Rezoning Transportation Analysis

Petition Number: 2019-053 General Location Identifier: 06702149

Date	Description	
05-15-19	First Review	
06-17-19	Second Review

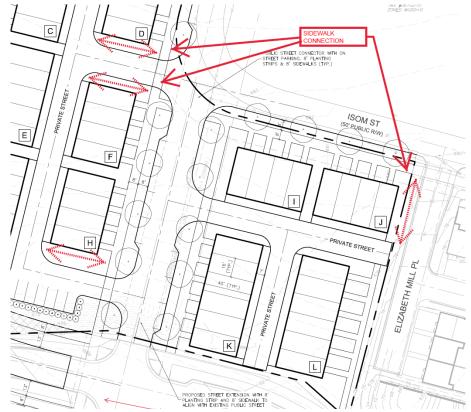
- 1. Curbline The proposed zoning district has a setback measured from back of the existing or proposed future curbline. The location of the future back of curb for:
 - Isom Street: 12.5 feet from centerline of the road.
 - Bryant Park Drive: 17.5 feet from centerline of the road (includes on street parking shown on site plan)
 - Morton Street: 14.5 feet from centerline of the road.

The petitioner should revise the site showing the location of the curb and gutter for all the roads and add a conditional stating the commitment to building the curb and gutter. (Site Plan: 03-21-19)

- 2. Traffic Study A Traffic Impact Study is not necessary for the complete review of this petition. (Site Plan: 03-21-19)
- 3. The petitioner should revise the site plan and conditional notes showing and stating the intersection of Isom Street and Bryant Park Drive will be built as a 4-legged intersection and meet USDG Standards. (Site Plan: 03-21-19)

- 4. The petitioner should revise the site plan and conditional notes to show proposed east-west private street connecting to Elizabeth Mill Place at Irwin Stream Road. (Site Plan: 03-21-19)

- 5. The petitioner should add a conditional note committing to coordinate the improvements on Bryant Park Drive with Rezoning Petition 2019-056 to the north of the site during the permitting process. (Site Plan: 03-21-19)

- 6. The petitioner should revise the site plan and conditional notes to commit to constructing a 5' sidewalk at the back of curb along Elizabeth Mill Place and the internal Private Street. (Site Plan: 03-21-19)

- 7. The petitioner should revise the site plan to add a note specifying dedication and fee simple conveyance of all rights of way to the City before the site's first building certificate of occupancy is issued. CDOT requests right of way set at 2' behind back of sidewalk where feasible. (Site Plan: 03-21-19)
- 8. The petitioner should revise the site plan to add a note specifying all transportation improvements will be approved and constructed before the site's first building certificate of occupancy is issued. (Site Plan: 03-21-19)
